**GEGR 247283 - Replace EPDM Roof**

*Bidders' Questions and A/E Responses*

# GENERAL GRANT NATIONAL MEMORIAL
# NEW YORK, NEW YORK

## 247283 REPLACE EPDM ROOF

2 A2.2 WEST ELEVATION
SCALE (B)

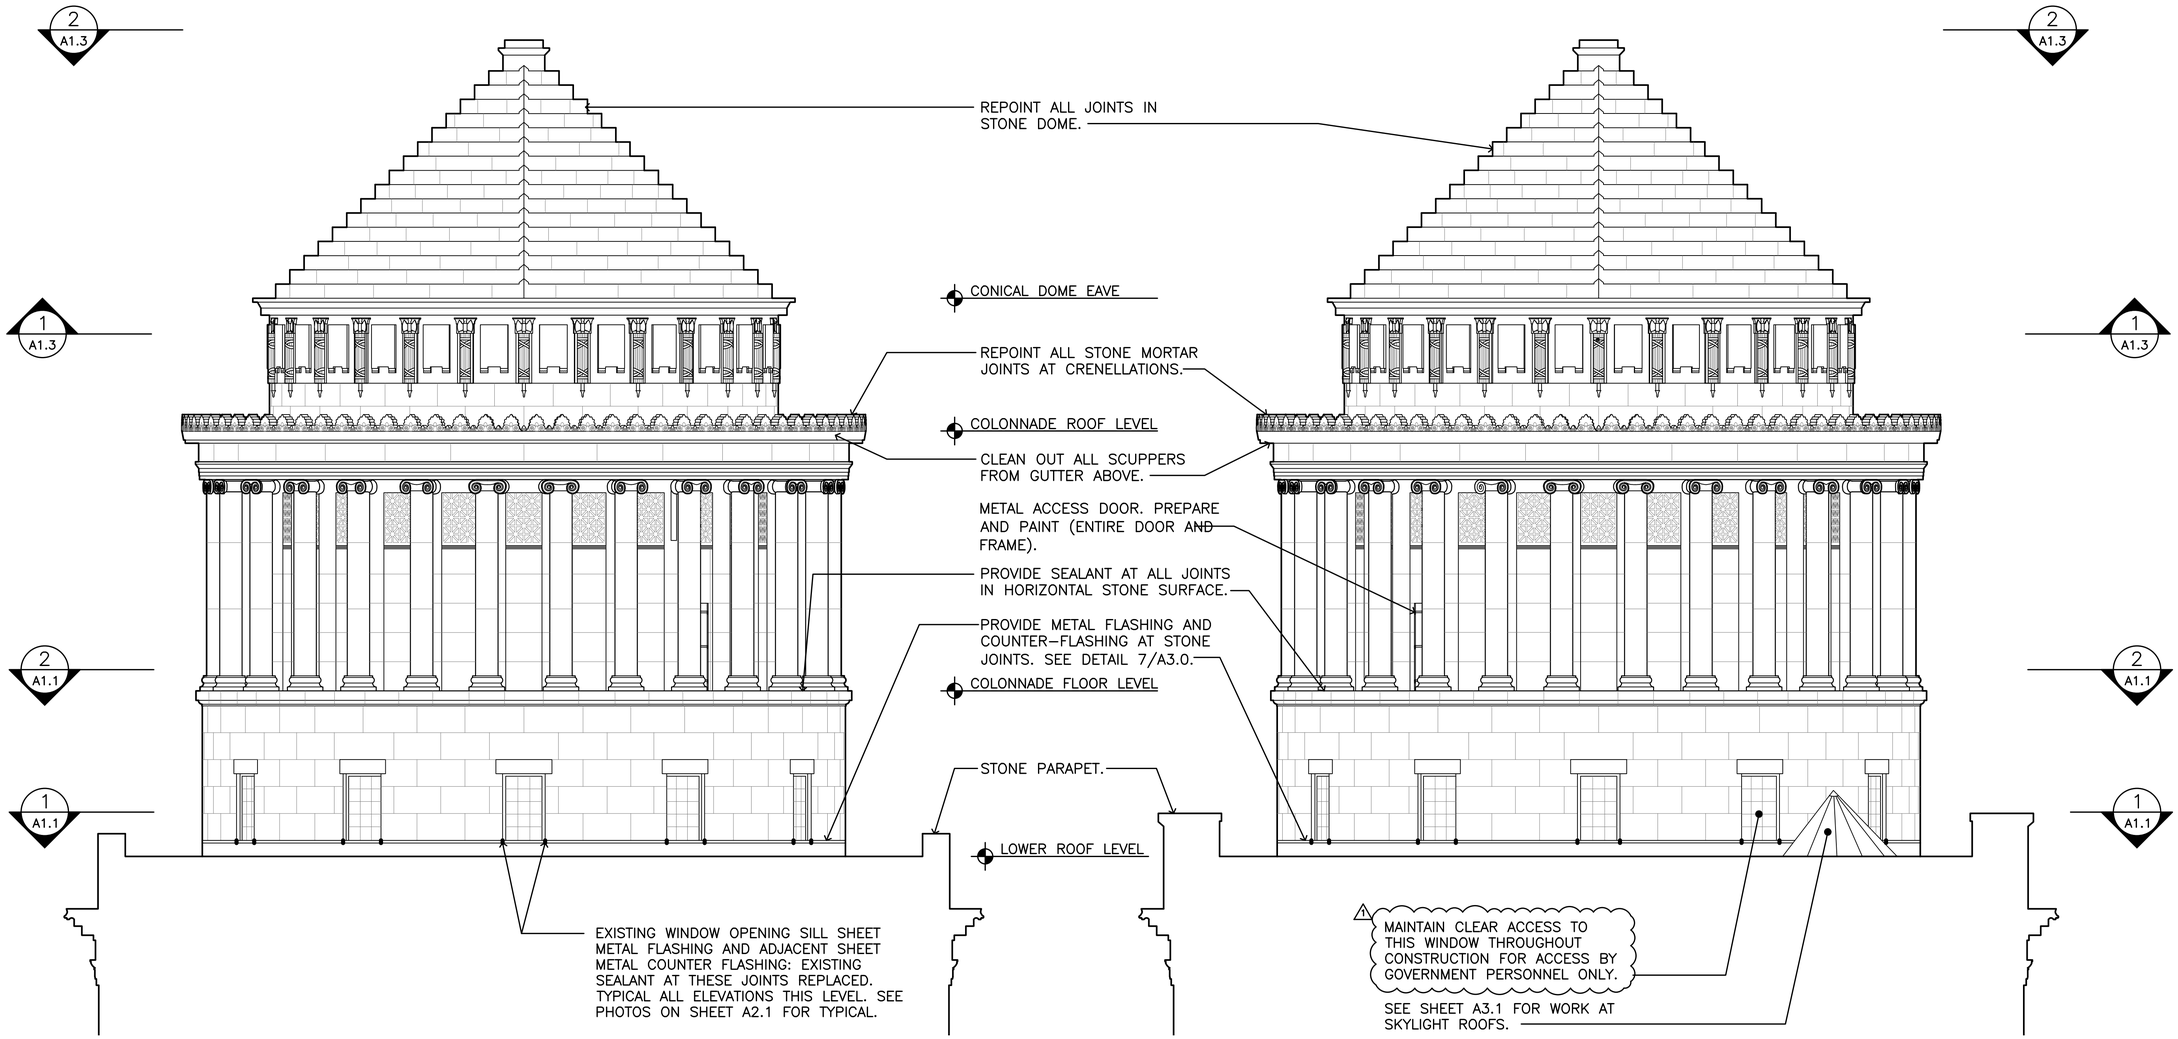
| 14 | Detail 2 / Sheet A2.2 – Government Personnel Window Access: Detail 2 on Sheet A2.2 references window access for Government personnel only. Please clarify the intent of this detail. Is the existing window to remain in place and be utilized for access, or is a new access window or modified assembly required as part of the project scope? | Refer to sheet A2.2 Revision 1 dated 06/16/26 for clarification on the intent of this detail. |

1 A3.1 TYPICAL ROOF DRAIN AND MEMBRANE FLASHING
SCALE J

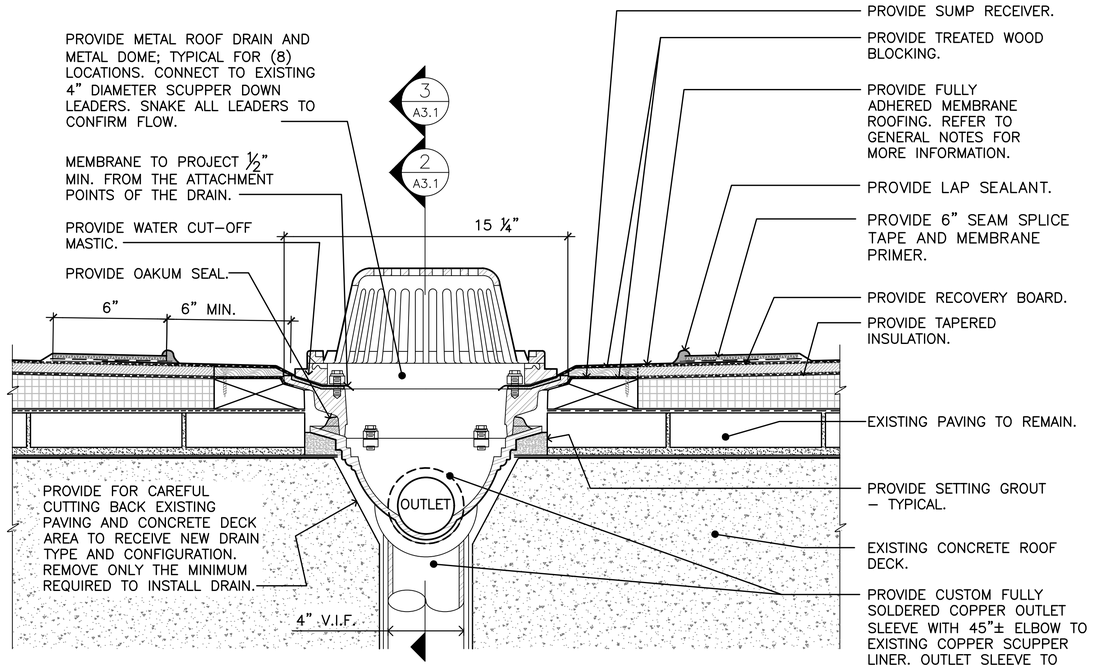
| Number | Question | Response |
|---|---|---|
| 7 | Drain Scope Clarification: Drain details are shown; however, the extent of replacement is unclear. Are existing drain bodies intended to remain in place with only flashing, clamping rings, and strainers being replaced, or is replacement of drain bowls and associated piping anticipated as part of this project? | Roof drains are being replaced as per details 1, 2, & 3 on Sheet A3.1 of the contract drawings, and Section 22 14 23 STORM DRAINAGE PIPING SPECIALTIES. Existing copper scupper liners are to remain, provide custom fully soldered copper outlet sleeve from new roof drain body to extend 12" min. into existing liner as per details. |

5 A3.1 DETAIL – COLONNADE MEMBRANE ROOF AND FLASHING
SCALE H

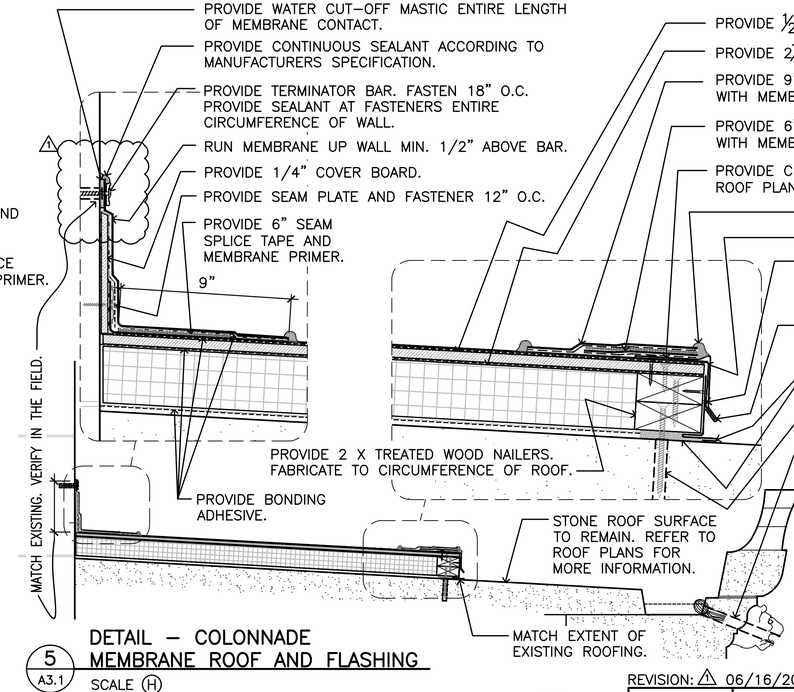
| | Detail 5 / Sheet A3.1 shows coverboard extending vertically with sealant applied at the top termination. Carlisle has advised that this condition may not meet their 30-year warranty requirements due to long-term sealant deterioration and potential moisture intrusion. Please confirm whether an alternate manufacturer-approved termination detail may be utilized to maintain warranty eligibility. | Refer to sheet A3.1 Revision 1 dated 06/16/26 for clarification on roofing details at this location. |
